<b>COA #</b> <b>2014-COA-059</b> <b>(ONS)</b>	<b>INDIANAPOLIS HISTORIC PRESERVATION</b> <b>COMMISSION</b> <b>STAFF REPORT</b>	Hearing Date <b>APRIL 2, 2014</b>
<b>231 E. 16<sup>th</sup> STREET</b> <b>OLD NORTHSIDE</b>		New Case   Center Twp. Council District 9 Joseph Simpson
<b>Applicant</b> <b>WILLIAM W. BROWN</b> mailing address: 1528 N. Alabama Street Indianapolis, IN 46202		
<b>Owner: SAME AS ABOVE</b>		
<b>CASE</b>		
<b>IHPC COA: 2014-COA-059 (ONS)</b>	<ul style="list-style-type: none"> <li>• Remove existing transom windows; install new windows in multiple sections</li> <li>• Install beam above storefront windows and below transom windows</li> <li>• Install new frames around storefront windows</li> <li>• Remove existing bulkheads; install bulkheads made of Azek trim and fiber-cement panels</li> </ul>	
<b>STAFF RECOMMENDATION: Approval of a Certificate of Authorization</b>

**Multi-light transoms**

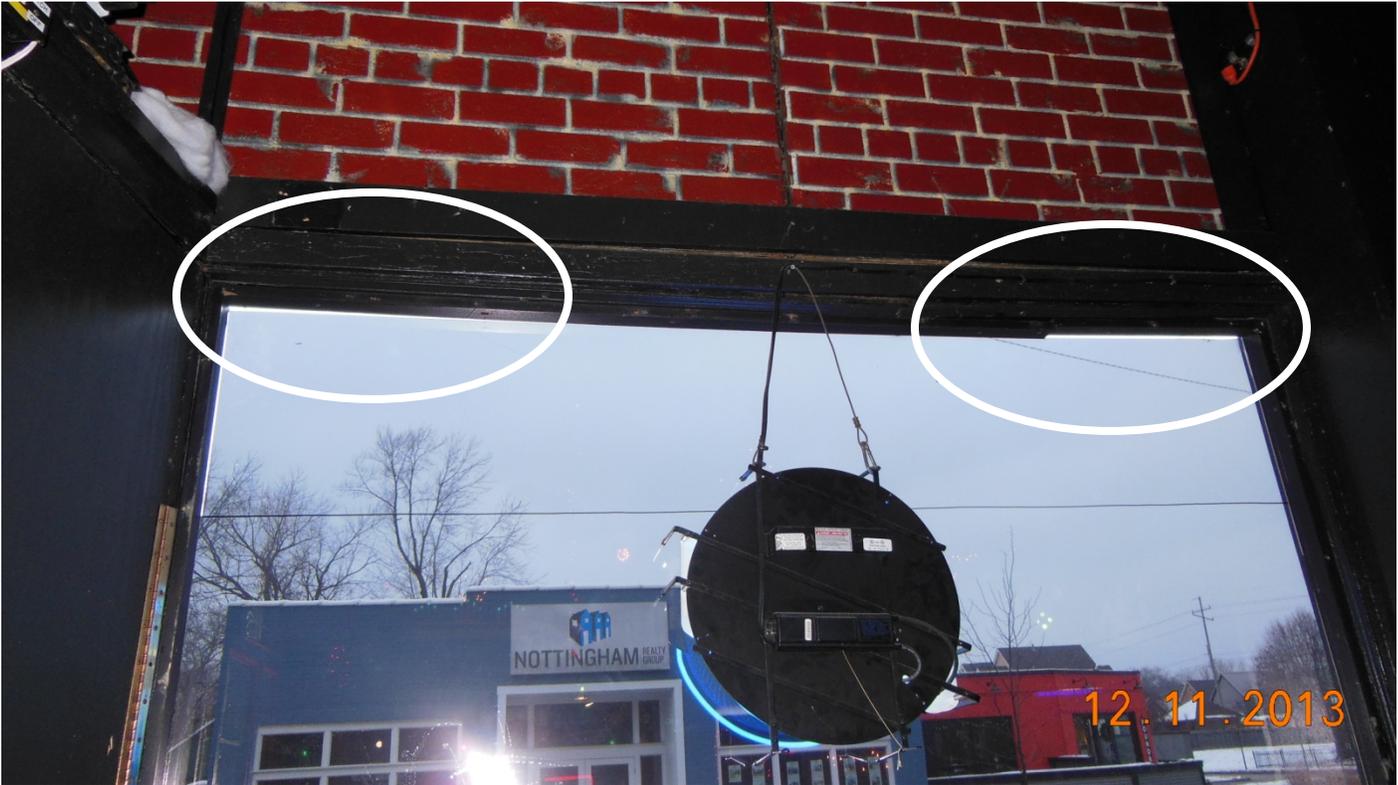
The owner wishes to rebuild the transoms over four storefront bays because there are structural deficiencies with the way they are presently built. The transom over each bay is built as one unit and rests on a 2 x 4 wood beam, which is meant to carry the weight. However, the beams were installed horizontally and are not sufficient to carry the weight. Over time they have flexed and the weight is being transferred to the storefront window frames below. This is causing serious problems such as gaps developing between the frame and the plate glass windows below.

The solution being proposed is to remove the four large transom window units and replace the deficient beam with a new wood beam made of two 2 x 4s laid vertically, which would have significantly more strength. New molding would cover the wider beam. In order to accommodate the wider beam, slightly shorter transom windows would be built and installed above the new beam. They will be built to look very similar to what is there today, but in multiple sections rather than one large piece. New wood frames would be installed for the large plate glass storefront windows below the transoms.

1. **IHPC staff shall sign off on bulkhead and storefront window frame after first unit has been installed. *Approved: \_\_\_\_\_ Date: \_\_\_\_\_***

2. **Glass shall be clear; any addition of beveling, frosting, etching, coming, or stained glass is NOT permitted under this approval.**
  3. **All new, repaired, and/or rebuilt elements shall replicate the documented historic appearance of the windows per IHPC photographs.**
